Overview

Staff's Role

Drawdown Analysis

Figure 7. This Recovery Analysis for the Big Gulch Stock Well with Revised Water-Level Trend Correction

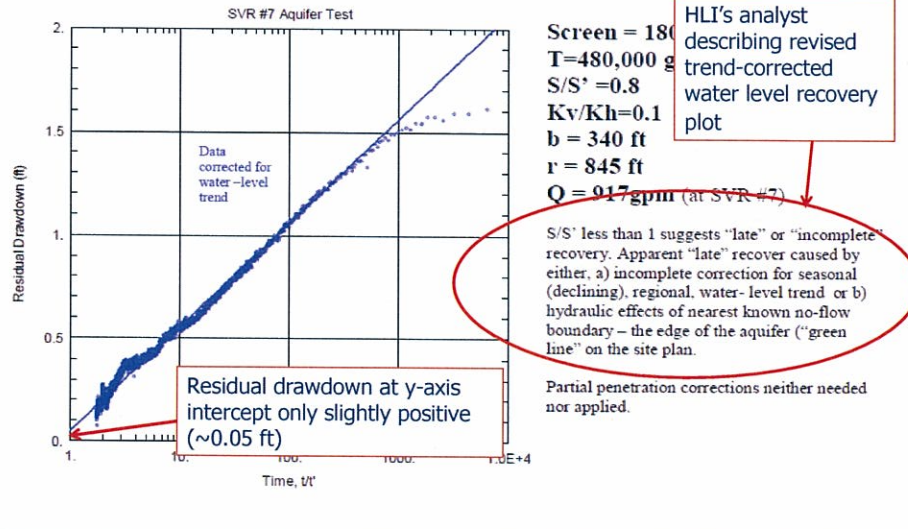
Here then is Figure 7 from the Response to the Staff Memorandum, Exhibit 45. This figure is a plot of the water level recovery data from the Big Gulch Stock well after applying the revised correction, which you'll recall is based on analysis of data that were collected in this same well after the test had been conducted. With the revised correction, the residual drawdown at the y-intercept is only slightly positive, approximately five hundredths of a foot. Nonetheless, HLI's analyst again acknowledges the possibility of late or incomplete recovery but this time indicates that it was "caused either by: a) incomplete correction for seasonal, declining, regional water-level trend, or b) hydraulic effects of nearest known no-flow boundary, the edge of the aquifer green line on the site plan."

Figure 23. This Recovery Analysis for Well SVR #7 with Trend Correction

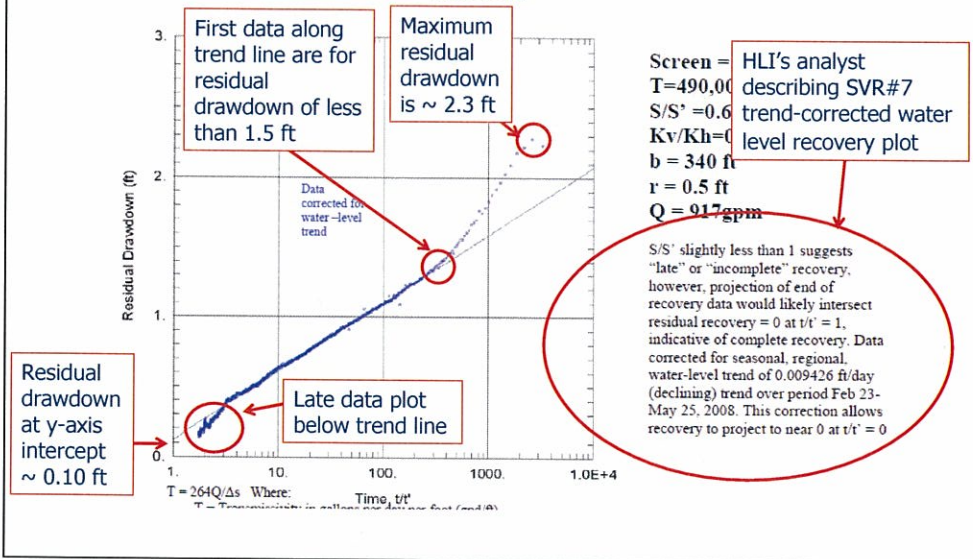
This is Figure 23 from Exhibit 44, which purportedly is a plot of trend-corrected recovery data from the SVR#7 pumping well. Note that the trend-corrected residual drawdown at $t/t' = 1$ for the pumping well is approximately one-tenth of a foot, which is somewhat larger than for the Big Gulch Stock well. Again the caption acknowledges that the recovery appears to be late or incomplete based on the trend line but, unlike in the case of Figure 27 for the Big Gulch Stock Well, the analyst considers late data that don't plot along the trend line in concluding *"projection of the end of recovery data would likely intersect residual recovery = 0 at $t/t' = 1$, indicative of complete recovery."* Beyond pointing out this inconsistency in the treatment of the late recovery data, the reason that I wanted to drag everyone through this rather difficult material is to emphasize that the regional water level trend corrections that were applied to the recovery data effectively mask the true response of the aquifer. In other words, the drawdown that was caused by pumping in the two wells with the most drawdown, SVR#7 and the Big Gulch Stock well, is not of sufficient magnitude in relation to the various water level correction factors to definitively assess whether or not the aquifer recovery was delayed or possibly even incomplete. The fact that uncertainty about the regional water level trend was used to explain residual drawdown intercepts of both 0.05 feet and 0.25 feet in the Big Gulch Stock well and 0.1 feet in the nearby SVR#7 well supports the idea that, in the case of the SVR#7 test, where the maximum recoveries are only on the order of a foot or two, a well-specific regional trend analysis based on data that were collected after the test makes evaluation of aquifer boundary conditions using the water level recovery data tenuous. Based on this figure, it is our opinion that the aquifer was not stressed enough by pumping at 900 gal/min for 9 days to facilitate a more definite analysis of the recovery data.

Before we move on from Figure 23, I want to point out that the first data points to plot along the trend line, which I've circled in red, are for residual drawdown values of slightly less than 1.5 feet and the maximum residual drawdown value of any data point is approximately 2.3 feet, which I've also circled in red.

The 2.3-foot maximum residual drawdown suggests that there may be a problem with Figure 23, which again is the trend-corrected water level recovery plot for the pumping well during the 9-day SVR#7 aquifer test. Table 2 from Exhibit 44, the SVR#7 aquifer test report indicates that the maximum measured drawdown in the pumping well was 29.79 feet and that, after correcting for well loss, the maximum drawdown in the pumping well was 7.51 feet. The 2.3-foot maximum residual drawdown on Figure 23 is therefore more than 5 feet less than the maximum drawdown after correcting for well loss. This rather large and unexplained discrepancy suggests to staff that the data shown are Figure 23 may not be representative of water levels in the pumping well during recovery.

EXHIBIT 67

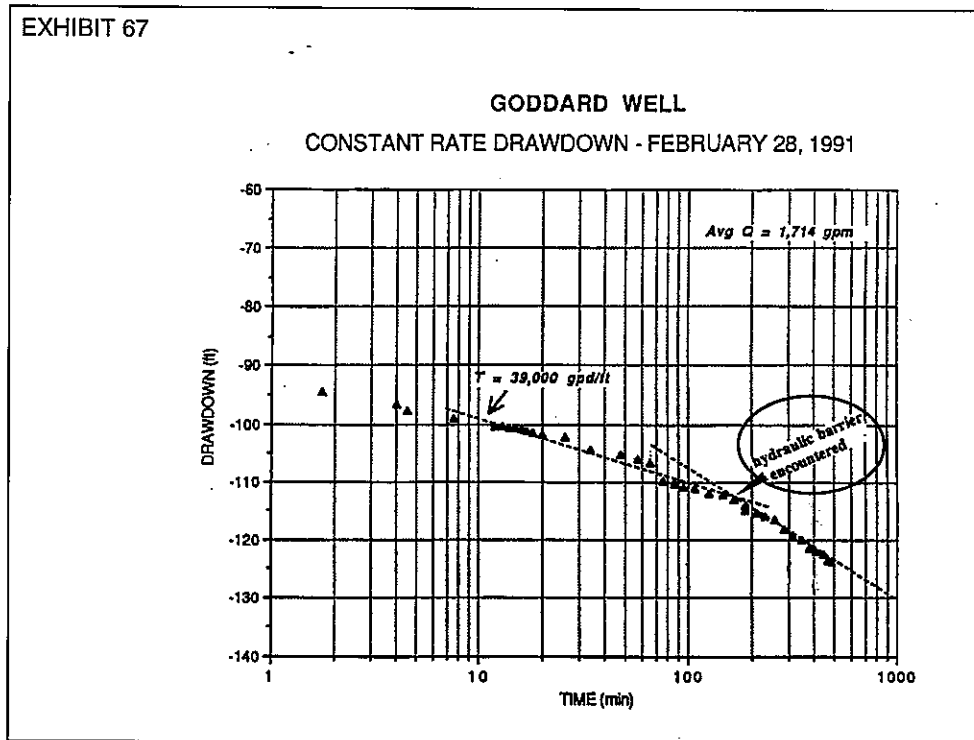
Squires, Wood, and Osiensky documented that the 551-foot deep Goddard #2 well is impacted by a hydraulic barrier (i.e., no-flow) boundary in their 1992 report entitled Hydrogeologic Framework of the Boise Aquifer System, Ada County, Idaho (Exhibit 67). They also presented an aquifer test data plot for the Goddard #2 well and identified the point on the curve where there was an increase in the slope of the drawdown trend as indication of a negative hydraulic barrier. According to HLI's Response to our Staff Memo, Goddard No. 2 is a PGSA well (Exhibit 45, p. 27) so there apparently is some sort of flow barrier in the PGSA between M3 and the postulated recharge area. As I mentioned earlier, Goddard #2 nonetheless has been in production for more than a decade so my concern is not that this well taps into a hydraulically isolated portion of the aquifer, but rather that M3's numerical model might not be an accurate predictor of impacts since it does not simulate this hydraulic barrier.

EXHIBIT 67

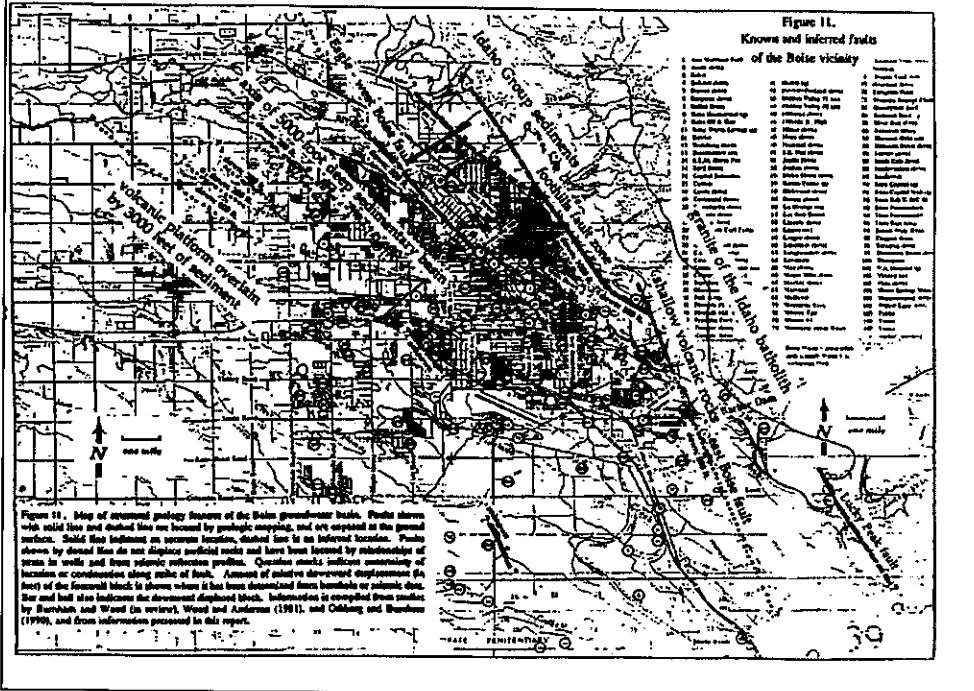
However, inspection of Figure 11 within the 1992 report, Exhibit 67, suggests that the Swift well, which I've identified with a small red dot, is on the upthrown side of the West Boise/Eagle fault, which I've emphasized with a dashed red line. The estimated offset across the fault is 800 feet, which is indicated on the left side of the fault trace below the large red arrow. If this is the case, hydraulic communication between this newly identified recharge area near the Swift well and the PGSA at M3 likely is limited by the fault.

Figure 3. Contours on the Bottom of the Pierce Gulch Sand Aquifer in the Greater M3 Eagle Project Area

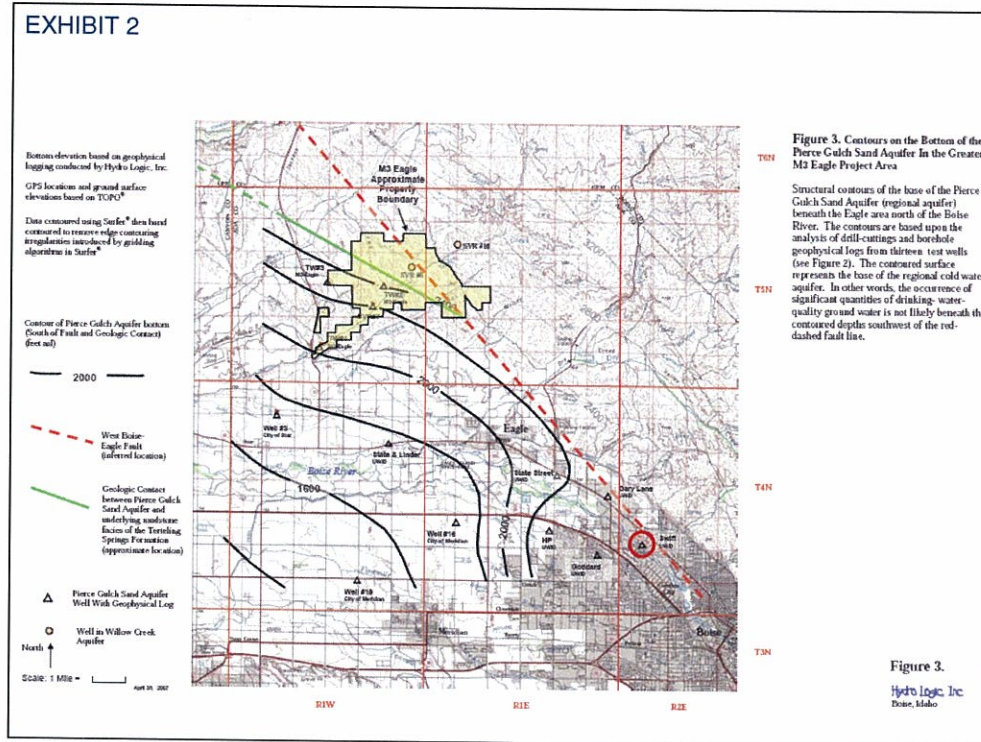
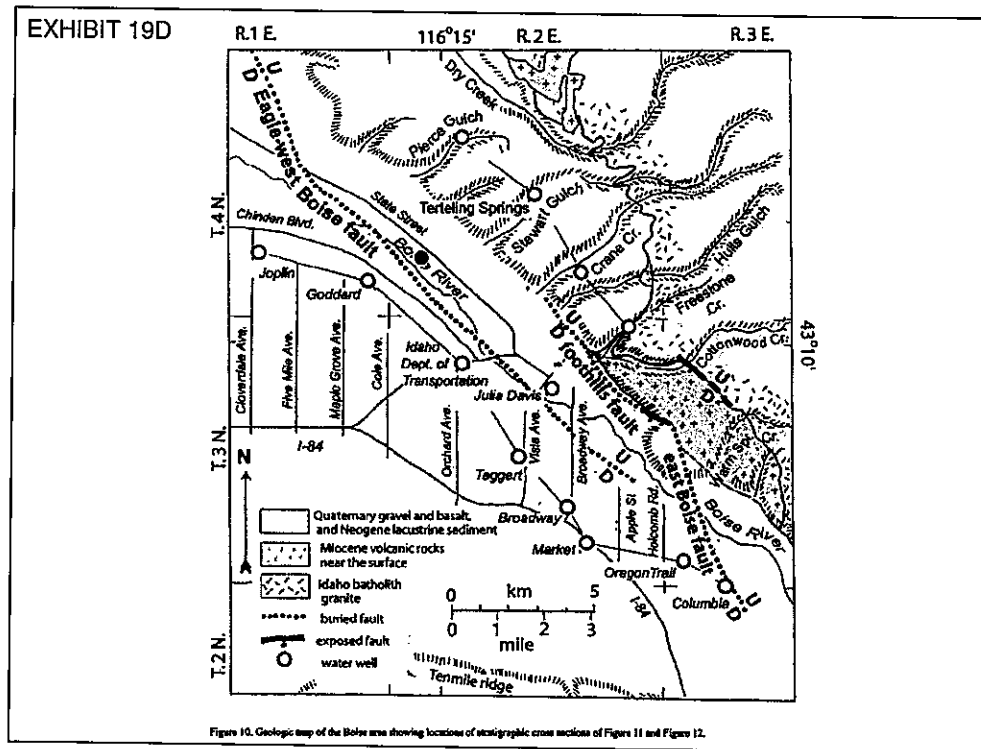
4 - in HLI's 2007 report (Exhibit 2), the Swift well, which I've circled in red, is located on the downthrown side of the West Boise-Eagle fault on the map showing the extent of the bottom of the PGSA. Note that the fault is located on the northeast side of the Boise River near the Swift well on this figure. This indeed suggests that there may be hydraulic continuity between the PGSA at M3 and beneath Garden City, but, as previously discussed, this fault location is different than shown on the map in the 1992 Report (Exhibit 67).

Figure 4. Hydrogeologic Cross Sections based on Deep Exploration Well Borehole Geophysical Analyses (from Wood)

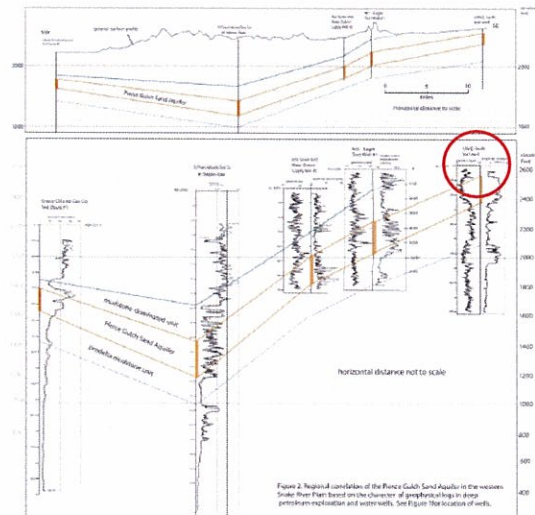
5 - the driller's log, and the near-surface geophysical signature for the Swift well, which I've circled in red in the upper right corner of Figure 4 from Exhibit 45, indicate that there is at least 30 feet of blue clay on top of what HLI identified as the PGSA. The surficial clay layer shows up as a kick to the right on the gamma log, which is the left strip chart in the area that I've circled, and a deflection to the left on the resistance log, which is the strip chart on the right. If laterally continuous, that clay layer would limit hydraulic communication between the PGSA and the alluvial aquifer system. As discussed by Mr. Glanzman, the geochemistry data indicate that PGSA groundwater has not had much contact with clay, which also suggests that communication with the Boise River is not significant in the vicinity of the Swift Well.

EXHIBIT 2

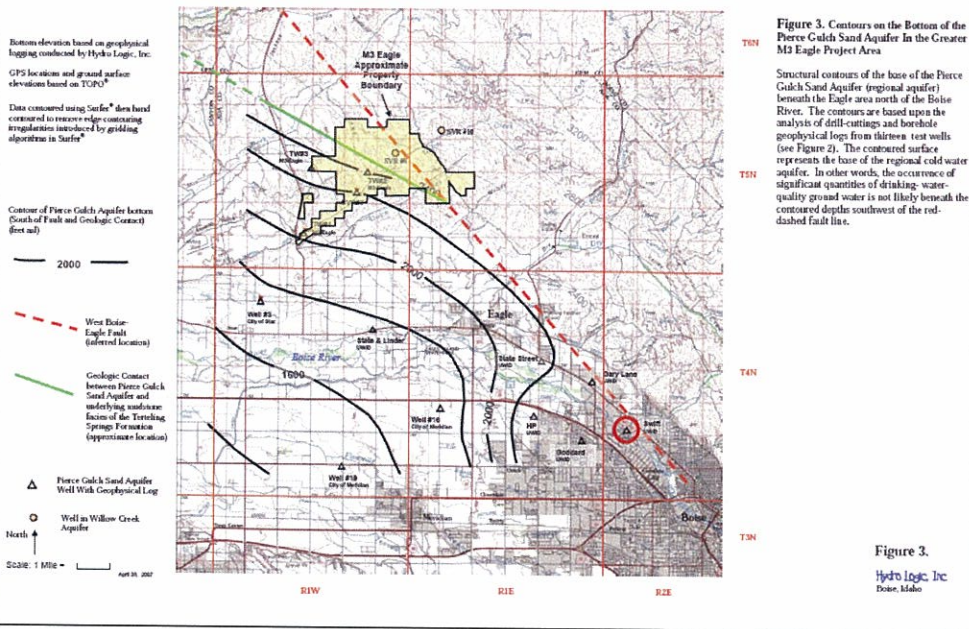
6 - the figure showing the bottom of the PGSA in HLI's 2007 report, Figure 3 from Exhibit 2, does not show contour lines east of the Garden City Fairgrounds or south of Cloverdale Avenue. The contours also do not extend west beyond the Canyon/Ada County line or into Gem County. The lateral extent of the PGSA shown on this figure based on geologic data is therefore considerably smaller than the modeling domain of the M3 numerical model.

Figure 88. Theis Analysis for TW#1 Zone 1 – Kling Irrigation Two-Day Test
Test Conducted: January 9-11, 2007

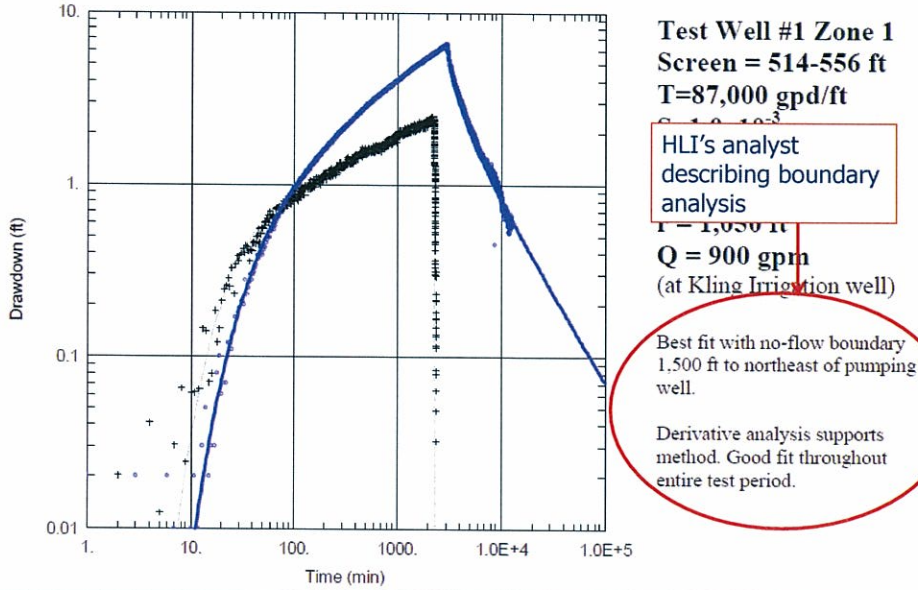
Here's a copy of a drawdown data plot from the Kling irrigation well test. It's Figure 88 from Exhibit 12. I want you to notice the notation that's been highlighted with a red circle. It says "Best fit with no-flow boundary 1,500 feet to northeast from pumping well". And then below that it says, "Derivative analysis supports method. Good fit throughout entire test period". I really don't see how it can be considered speculative on the part of staff to think that the fault that was identified by Wood in the panhandle of M3's property approximately 1,500 feet northeast of the Kling irrigation well acts as a no-flow boundary, when it was HLI's own analyst that first proposed the idea in a submittal to the Department.

Figure 2. Subsurface Seismic Reflection Profiles (from Wood)

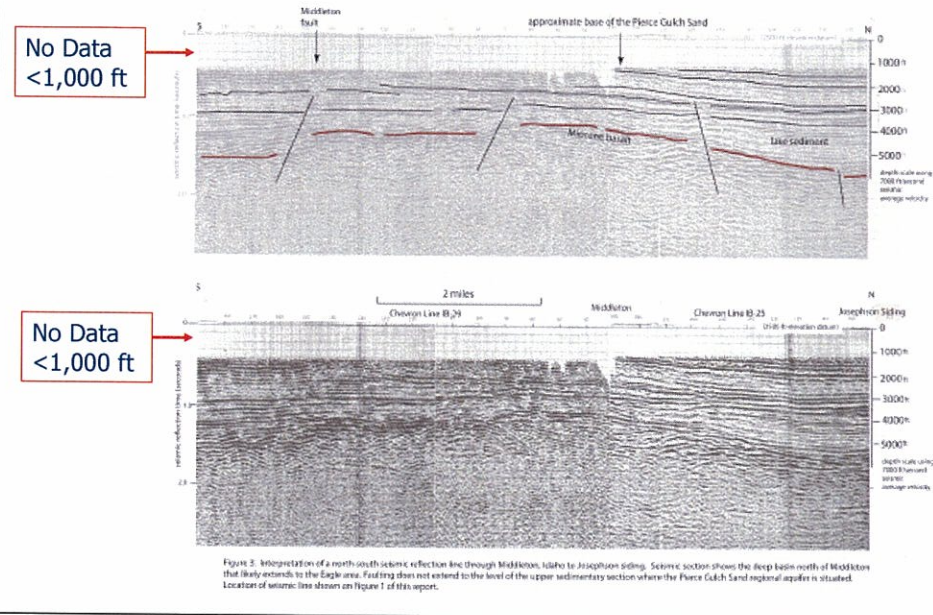
Inspection of Figure 2 reveals that it can't be used directly to support that argument since the beginning depth of the profile is greater than 1,000 ft. There simply are no data in the shallow section that includes the target aquifer. Indeed, the deep faults aren't shown as propagating to land surface on this figure but, based on the information in one cross-section that doesn't extend into the shallow section, it's unclear whether the understanding of the hydrogeologic significance of shallow faults has improved since the 1992 report, which, at that time, described the level of understanding as poor.
